- 4. Leisure time Estates Ivy Replat
KPB File 2022-130**

ITEM 4 – LEISURE TIME ESTATE IVY REPLAT

STAFF REPORT

**PLAT OF
LEISURE TIME ESTATES IVY REPLAT**

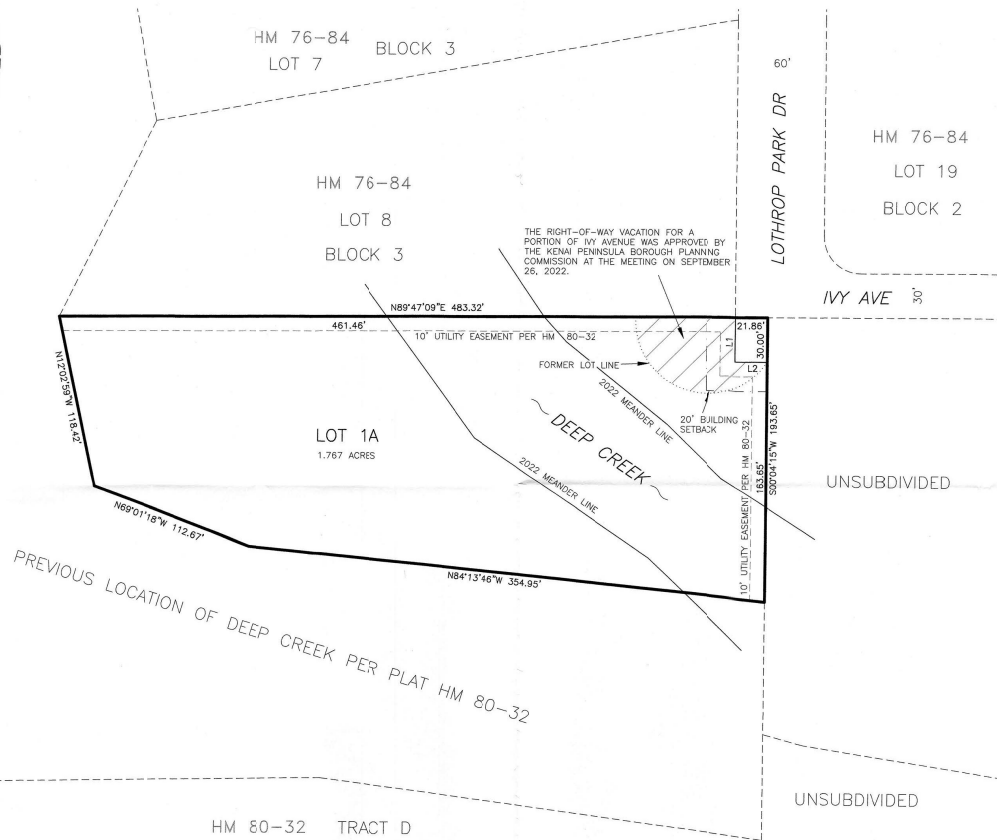
A label is provided for the vacation on the face of the plat. ***Staff recommends adding to the note the date the Assembly granted consent.***

There is a cabin and shed located on the property. The shed is completely within the right-of-way and the cabin has a portion within the cul-de-sac. The location of the cabin appears to be closer than allowed to the edge of Deep Creek. The owner has stated to staff that he has documentation that allowed the location. This is an issue to be reviewed by the River Center and KPB Code Compliance. The recording of this plat will resolve the encroachments within the right-of-way. A new setback and utility easement will be granted along the new right-of-way edge. **Staff recommends the surveyor verify if any improvements will be within the setback or utility easement and if so, they should be depicted and additional plat notes will be required to show they are exempt to the setback/utility easement.**

The entire preliminary plat is considered wetlands with a Riverine designation. **Staff recommends a wetland determination plat note be added to the plat.**

The 2022 meander lines for Deep Creek are shown on the plat. **Staff recommends the source or method for determining the meander lines should be noted or labeled.**

The certificate to plat indicates an easement has been granted. The document provides the location for the easement. **Staff recommends the surveyor review the easement and determine if it applies to this property and provide a note with recording information if it does apply.**

Staff suggests that plat note 1 be split so that one note deals with the setback and another with the utility easements. The utility easement note could be combined with note 2 if desired. Due to the design of the utility easements along the north and east, the statement about 20 feet within 5 feet of the side lot line is not required. **Staff recommends the note regarding utility easements be revised, "The front 10 foot adjacent to dedicated rights-of-way is a utility easement granted by this plat. This plat will also be granting 10 foot utility easements along the boundary within the vacated area to provide continuations of the previously granted 10 foot utility easements."**

There is an easement issued by recorded document to Homer Electric Association. The easement refers to a specific transmission line but no specific location. **Staff recommends a plat note with the easement information be added unless it can be shown to staff that it does not apply to the subject property.**

Staff recommendation: Include SE1/4 in location description.

- J. Block and lot numbering per KPB 20.60.140, approximate dimensions and total numbers of proposed lots;
Staff recommendation: Add a block label to the lot to carry over the designation.

Staff recommendation: Due to the restraints created by Deep Creek and the minimal access to dedicated right-of-way a plat note should be added "There are possible limitations on further subdivision based on access issues, development trends in the area, or topography."

Staff recommendation: In addition to the overall acreage provide the acreage for dry area and submerged land. Provide boundary and lot closure computations with the paper final plat. KPB will verify closure complies with 20.60.120.

- *This is a paper plat. A field survey was not performed.*
- *Any person developing the property is responsible for obtaining all required local, state, and federal permits, including a U.S. Army Corps of Engineers wetland determination if applicable.*
- *There are possible limitations on further subdivision based on access issues, development trends in the area, or topography.*
- *Subject to a right-of-way easement to Homer Electric Association Incorporation within Serial 2019-000154-0, HRD.*
- *The natural meanders of ordinary high water is for area computations only, the true corners being on the extension of the sidelines and the intersection with the natural meanders.*
